Work Instructions – HVAC Relay & Fuse Block Revision

NHTSA Recall 26V-652
Author: E-ONE Engineering
Date: October 12, 2026

Step 4 - Remove Existing Bussmann Fuse Block

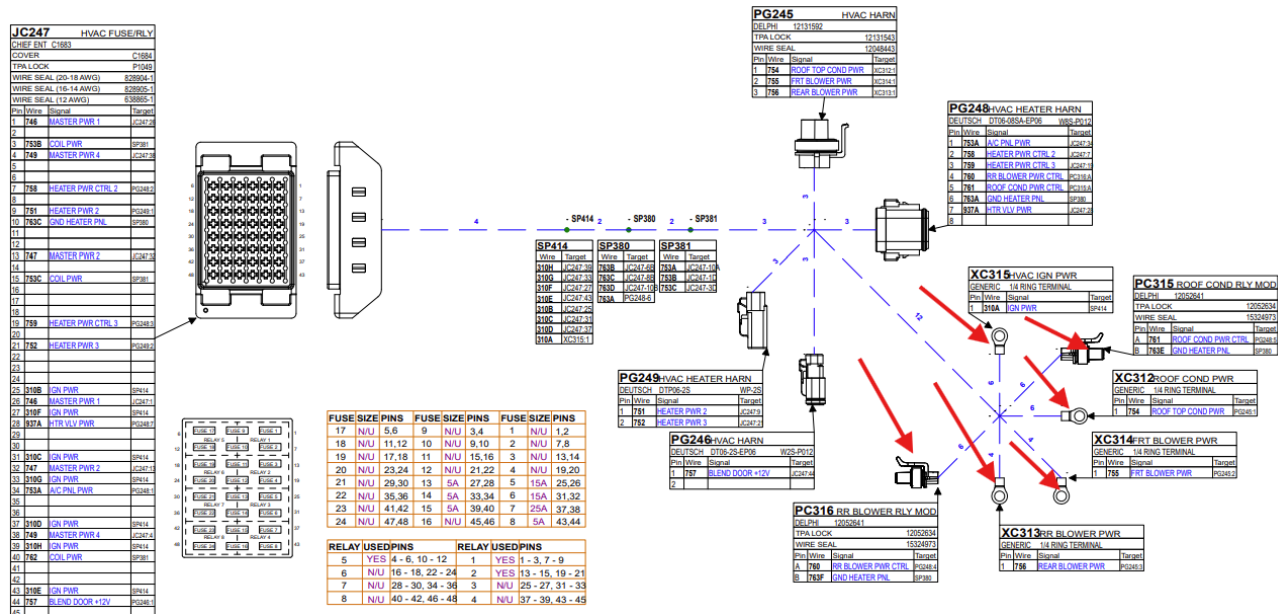
Disconnect and remove the existing Bussmann fuse block and the cable connecting the fuse block to the ignition solenoid.

Install the replacement HVAC harness in accordance with the applicable harness print and connector identification documentation. The replacement harness incorporates six new connections associated with the updated relay configuration.

Step 5 - Install Power Relay Fuse Modules

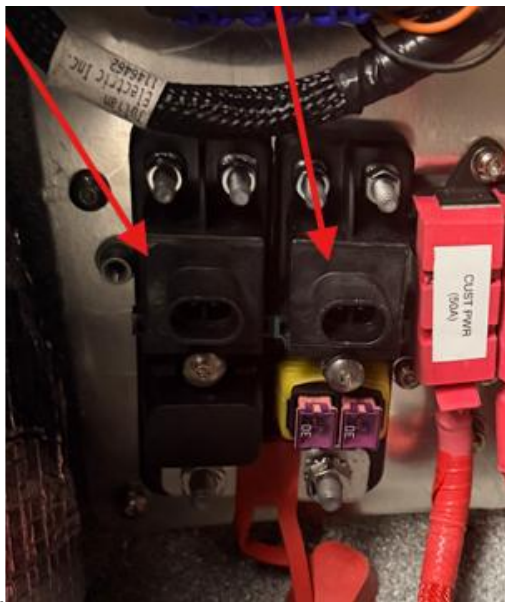
Install two Power Relay Fuse Modules (P/N 1121588) in the driver-side kick plate area as shown in the applicable engineering documentation.

Prior to installation, verify that four 30-amp fuses (P/N 1110116) are installed in the specified fuse positions.

Step 6 - Connect XC312, XC313, XC314, and XC315

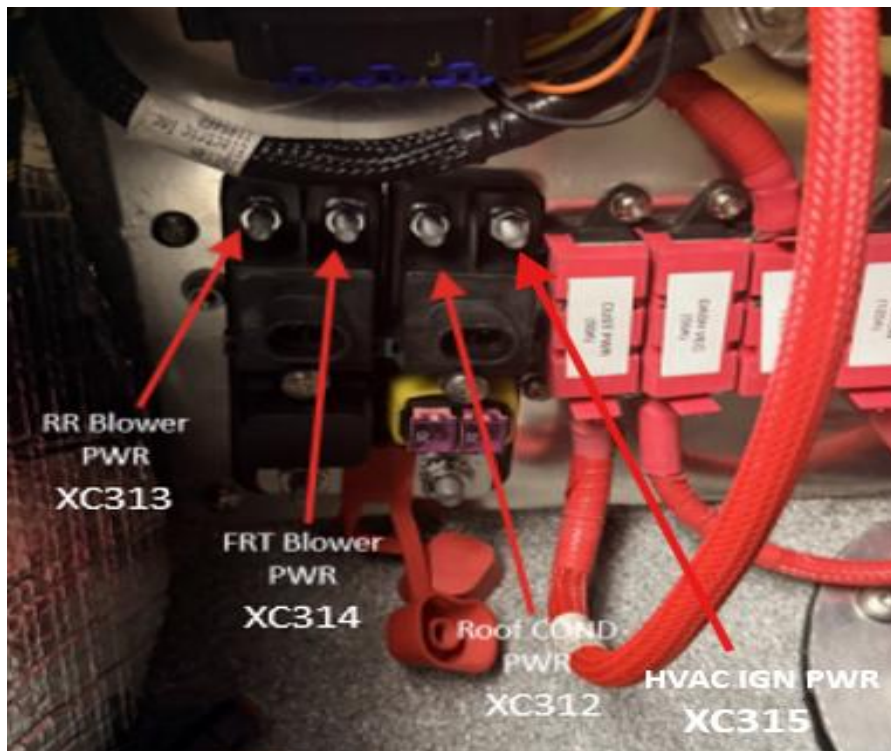
Install eyelet terminals:

- XC312
- XC313
- XC314
- XC315

onto the studs specified in the applicable harness print.

Step 9 - Install Power Cable

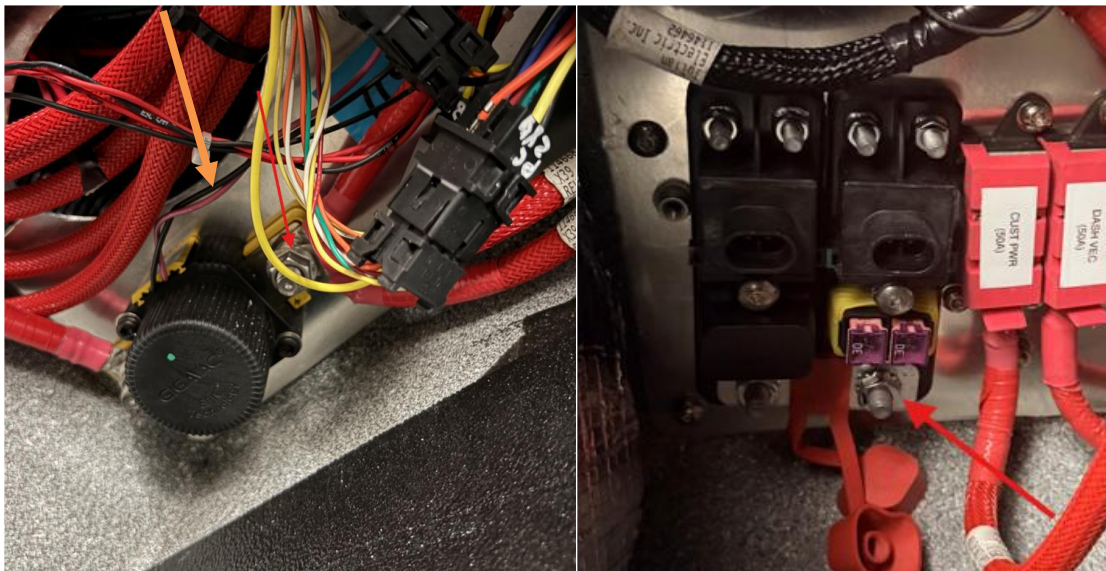
Install the supplied red power cable (P/N 1166364) between the ignition solenoid and the Power Relay Fuse Module in accordance with the applicable engineering documentation.

Connections installed on the M6 output studs of the Power Relay Module (P/N 1121588) shall be torqued to a maximum of **48 in-lb (5.4 N·m)** and M8 input studs of the Power Relay Module (P/N 1121588) shall be torqued to a maximum of **144 in-lb (16.3 N·m)**.
